| Project | <b>IEEE 802.16 Broadband Wireless Access Working Group</b><br>< <a href="http://ieee802.org/16">http://ieee802.org/16</a> > |  |

| Title | <b>Comments on the use of the TG1 MAC for TG3 Purposes</b> |  |

| Re: | IEEE 802.16.100/01r4, September 2000 |  |

**FIGURE 3. MAC PDU Format**

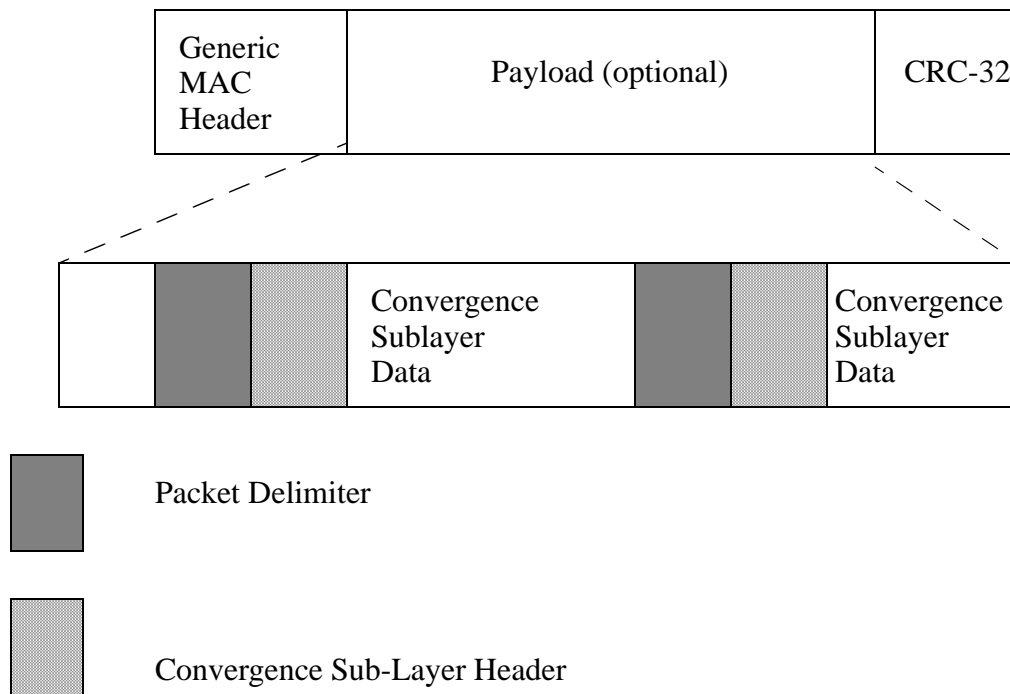
Replace the contents of Section 2.5 by the contents of Section 4.1 of this document.

MAC Protocol Data Units (PDU) shall be of the form illustrated in Figure 3. Each PDU is preceded by a fixed length generic MAC header. The PDU may contain optional payload information. The payload information can vary in length, so that a MAC PDU will represent a variable number of bytes. The payload information is divided into three parts: A two byte packet delimiter field (Figure 4), an yet to be defined convergence sublayer header and the data portion. This allows the MAC to tunnel various higher layer traffic types without knowledge of the formats or bit patterns of those messages.

**FIGURE 4. Packet Delimiter field**

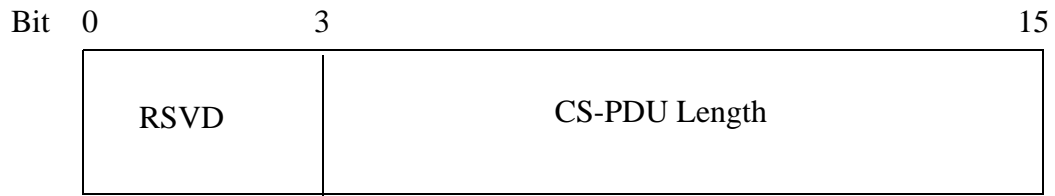
All Higher Layer PDUs (CS-PDUs) are preceded by a two byte delimiter field, whose format is shown in Figure 4. The size of the CS-PDU, in bytes, is inserted into this field.

**FIGURE 5. Upstream MAC Header**

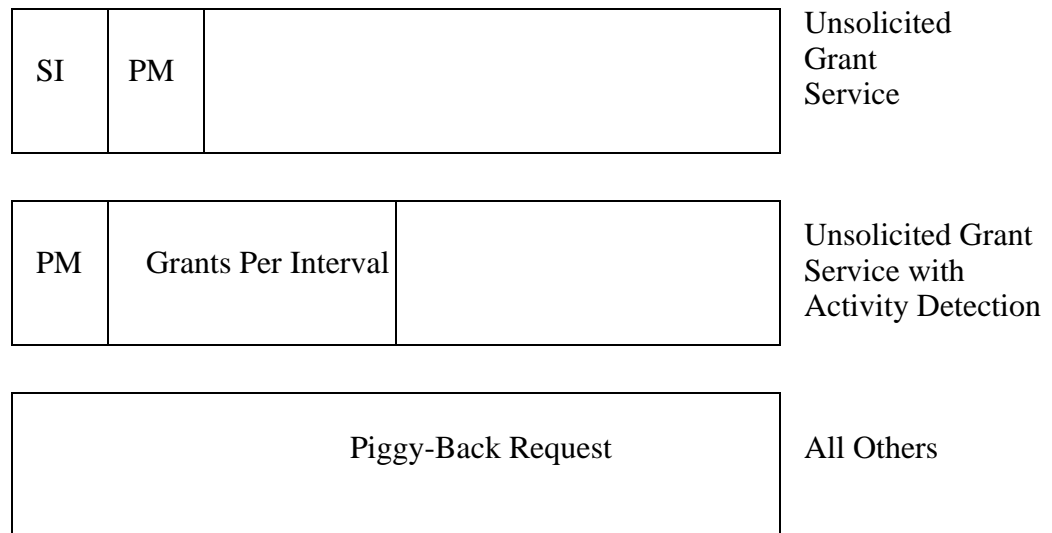
The format shown in Figure 5 shall be used for all PDUs transmitted by the SS to the BS in the uplink direction. For the downlink transmissions, the format shown in Figure 6 shall be used. These two generic header formats are equivalent with the exception of the Grant Management field, which is only present in uplink transmissions.

The Grant Management field is 2 bytes in length and is used to by the SS to convey bandwidth management needs to the BS. This field is encoded differently based upon the type of connection (as given by the Connection ID). The use of this field is defined in Section 2.10.

**FIGURE 7. Bandwidth Request Packet Header Format**

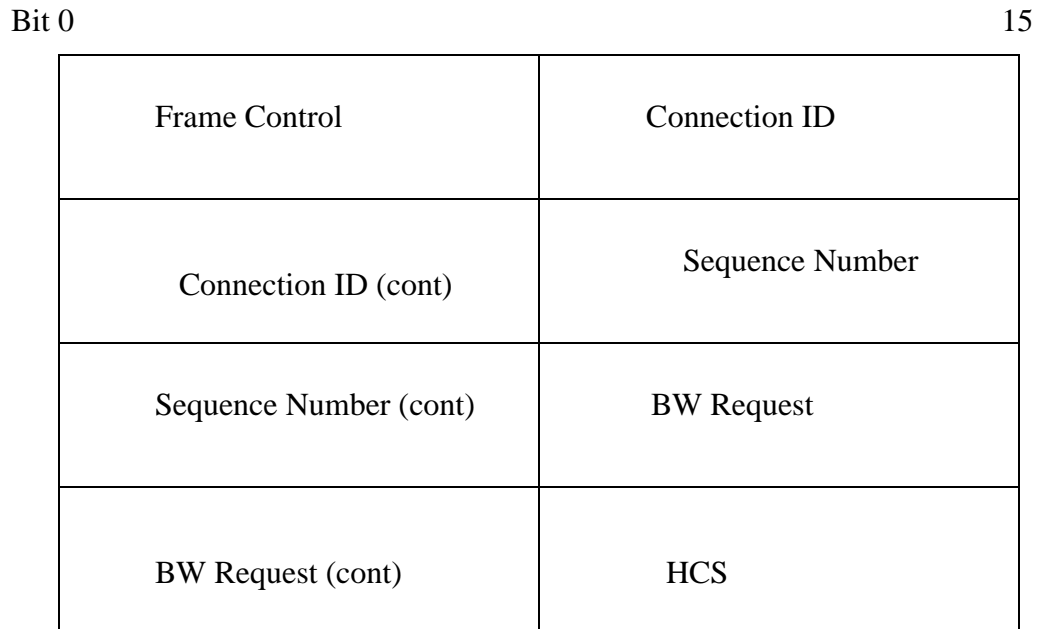
The third header is a special format used by a SS to request additional bandwidth. This header shall always be transmitted without a PDU. The format of the Bandwidth Request Header is given in Figure 7.

**FIGURE 8. MAC Management Packet Header Format**

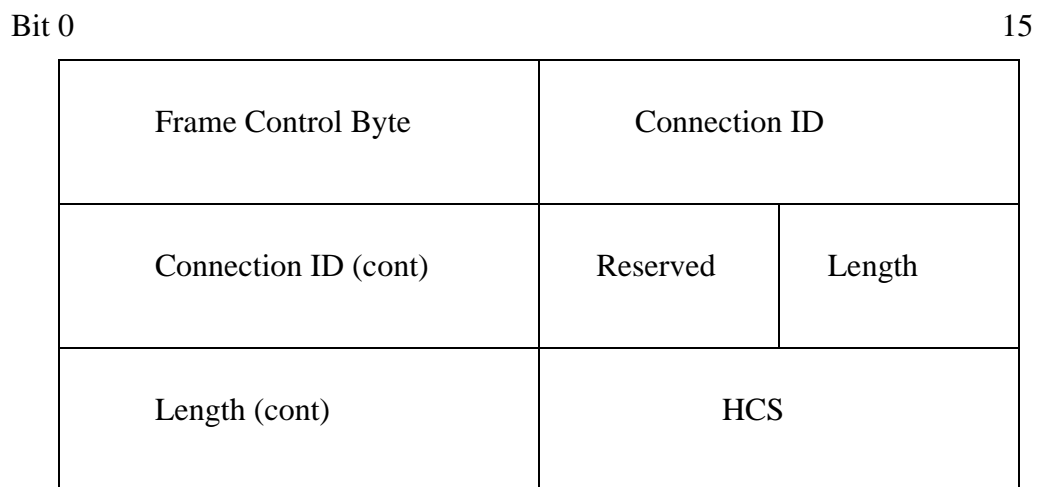
The fourth header shown in Figure 8, is a special format used for MAC Management messages.

**FIGURE 9. Upstream ACK Packet Header Format**

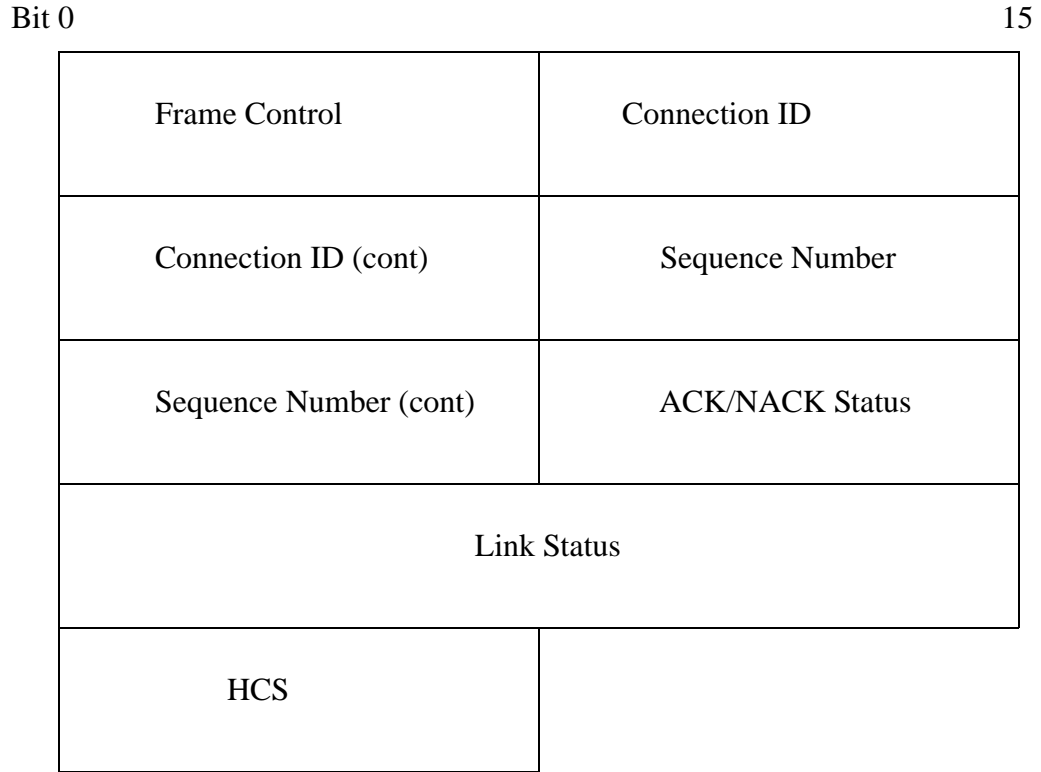
The fifth and final header format, shown in Figure 9, is used for upstream ACK packets.

**FIGURE 10. DL-MAP Information Element for ACKs for Upstream Data (DIUC = 6)**

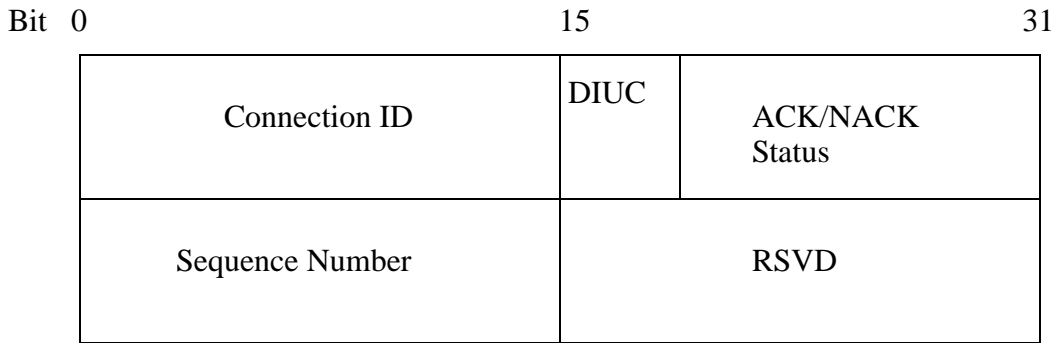
Add the following two figures and text to Section 2.5.3

**FIGURE 11. TDMA MAP Message Element Format for Downstream Data Grants**

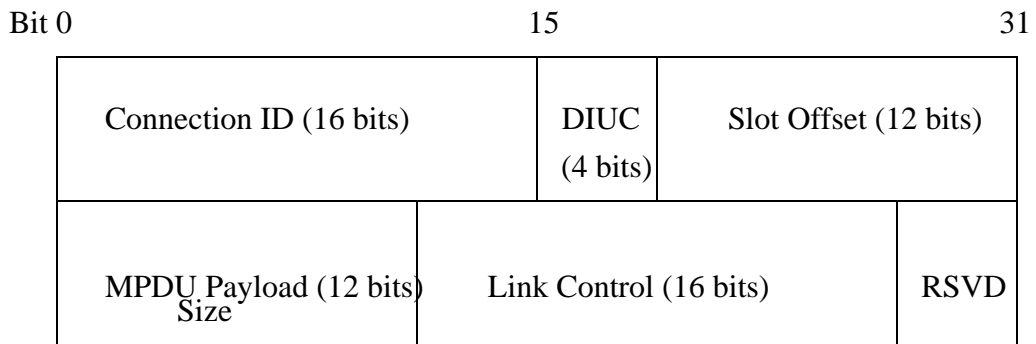
If DIUC is either 8, 9, 10, 11, 12, or 13, then the MAP IE should be as shown in Figure 11.

**FIGURE 12. TDMA MAP Message Element Format for Upstream Data Grants**

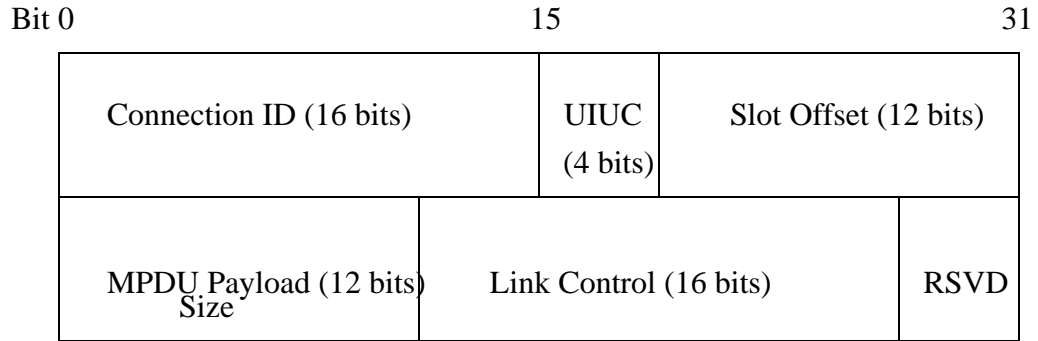
Add Figure 10 and the following paragraph to this section

If UIUC is either 4, 5, 6, 7, 8, or 9, then the MAP IE should be as shown in Figure 12.
